Palo Verde Nuclear  
Generating Station

**Subject: Palo Verde Nuclear Generating Station (PVNGS)  
Units 1 and 3, Docket Nos. STN 50-528 and STN 50-530  
Response to Request for Additional Information Regarding Steam  
Generator Replacement and Power Uprate – Instrumentation and  
Controls Section**

**Instrumentation and Controls Section,  
Electrical and Instrumentation and Controls Branch  
Questions and APS Responses**

**REQUEST FOR ADDITIONAL INFORMATION ON PVNGS UNITS 1 AND 3  
STRETCH POWER UPRATE FROM 3876 MW<sub>t</sub> TO 3990 MW<sub>t</sub>**

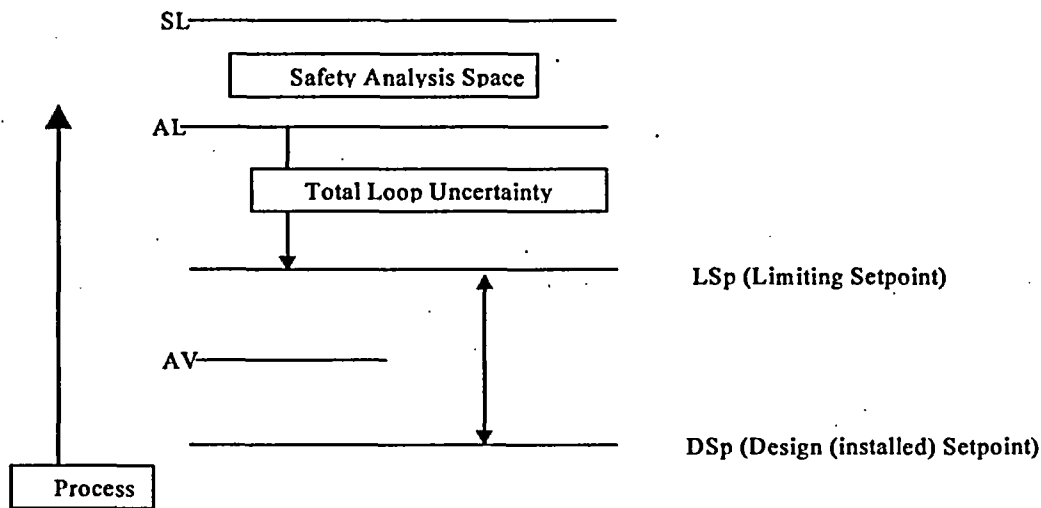
Discuss the setpoint methodology used at PVNGS to establish AVs associated with LSSS setpoints.

PVNGS is committed to RG 1.105 revision 1 with exceptions specified in the UFSAR, section 1.8, as a basis for meeting the requirements of 10CFR50, Appendix A, General Design Criteria 13 and 20. Our current practice provides more details than required by RG 1.105 revision 1. The setpoint project at PVNGS, by choice, used the principles of ANSI/ISA S67.04-1988, "Setpoints for Nuclear Safety-Related Instrumentation" and RP67.04 (then draft 9) in developing the design guide ("Design Guide for Instrument Uncertainty and Setpoint Determination" DSG-IC-0205) which was the method by which the calculations of the project were accomplished.

Of the three methods for determining the AV as described in Instrument Society of America (ISA) recommended practice ISA-RP67.04-1994, Part II, "Methodologies for Determination of Setpoints for Nuclear Safety-Related Instrumentation"; the PVNGS methodology is more similar to method 2 or 3, than method 1. This is because the total loop uncertainty (TLU), which is used to calculate a limiting (least conservative) setpoint (LSp), is determined by the Square Root Sum of the Squares combination of the COT (potential instrument uncertainties expected during Channel Operability Testing) and nCOT (composite of all other potential instrument uncertainties not addressed in the COT). Method 1 on the other hand, determines the TLU by adding the COT + nCOT.

The concern the Staff has (had) with respect to the ISA 67.04 Part II Method 3 is in the determination of the Allowable Value (AV). These concerns should not apply to the PVNGS methodology.

When PVNGS first developed the uncertainty and setpoint methodology and calculations, the Allowable Values listed in the Technical Specifications already existed based on the calculations provided by Combustion Engineering (CE). A goal of the PVNGS setpoint program was to clarify the methodology and resulting calculations, and if possible, avoid making changes to the existing Technical Specifications values or any field installed design setpoints (DSp) if the resulting calculations validated the existing values as conservative. The current PVNGS

calculations validate the existing Allowable Values. The Staff concern is that the methodology provides assurance that the AV is still satisfied by providing a large enough allowance for those uncertainties not measured during the operability test. The reason that the Staff finds either Method 1 or Method 2 acceptable is that the allowance between the Analytical Limit (AL) and the AV is defined by the magnitude of the nCOT. The PVNGS methodology and resulting calculation can demonstrate that the allowance between the AL and the AV exceeds the magnitude of the nCOT and that of the entire Total Loop Uncertainty (TLU) as well, for the LSSS value being changed under this LAR. The AL and thus, the associated Safety Limit (SL), will be preserved if a trip setpoint is found to be within the AV during surveillance testing. Therefore, operability is ensured in the Technical Specifications. The following figure shows these relative relationships (based on a rising process and high limit):

Total Loop Uncertainty = appropriate statistical combination of random and bias COT and nCOT terms.
